Access Compliance Report

Public Rights-of-Way

(Curb Ramps)

Intersection ID: 10023914	Main Street: CONFERENCE_DR	Cross Street: N/A	Location: SW
ADA ID: C19D57F341DF	Ramp Type: Perp	Initial Pass/Fail: Fail	Overall Compliance: No
Severity Score: 13.75			
Codes/Mitigation Info/Possible Solution		Field Measurements/Component Compliance

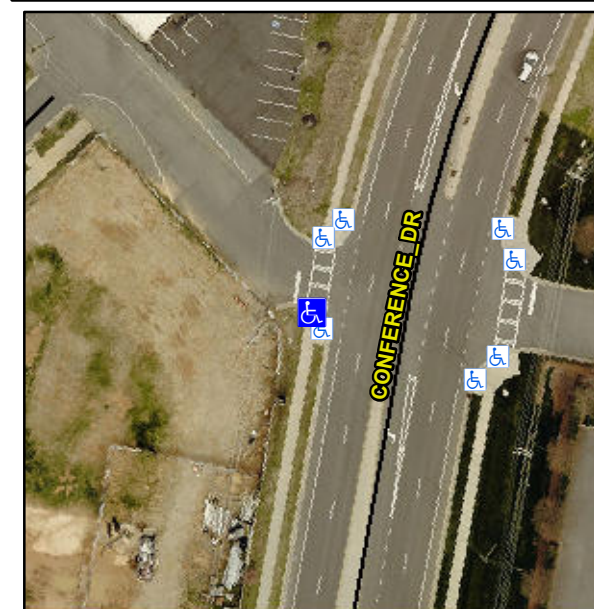
R304.2.2, R304.5.3

Compliance	Description	Data	Compliance	Description	Data
N/A	Ramp Length (in)	67.0	No	Ramp Slope (%)	9.6
Yes	Ramp Width (in)	48.0	No	Ramp XSlope (%)	3.7
N/A	Flare Type LT	N/A	N/A	Flare Type RT	N/A
N/A	Flare Slope LT (%)	N/A	N/A	Flare Slope RT (%)	N/A
N/A	Flare Traversable LT?	N/A	N/A	Flare Traversable RT?	N/A
N/A	Landing Length (in)	N/A	N/A	DWS Provided?	N/A
N/A	Landing Width (in)	N/A	N/A	DWS Contrast?	N/A
N/A	Landing Slope (%)	N/A	N/A	DWS Length (in)	N/A
N/A	Landing X Slope (%)	N/A	N/A	DWS Full Width?	N/A
N/A	Landing Curb? (Y/N)	N/A	N/A	DWS Offset (in)	N/A
N/A	Shared Landing?	N/A			
N/A	Gutter Ponding?	N/A	N/A	Gutter Slope (%)	N/A
N/A	Gutter Lip Ht (in)	N/A	N/A	Gutter X Slope (%)	N/A
N/A	Painted X Walk1?	Yes	N/A	Painted X Walk2?	N/A
	X Walk 1 Direction	To NE		X Walk 2 Direction	N/A
N/A	X Walk 1 Width (in)	111.0	N/A	X Walk 2 Width (in)	N/A
	X Walk 1 Slope (%)	1.0		X Walk 2 Slope (%)	N/A
	X Walk 1 X Slope (%)	2.6		X Walk 2 X Slope (%)	N/A

Remove & Replace Entire Ramp.
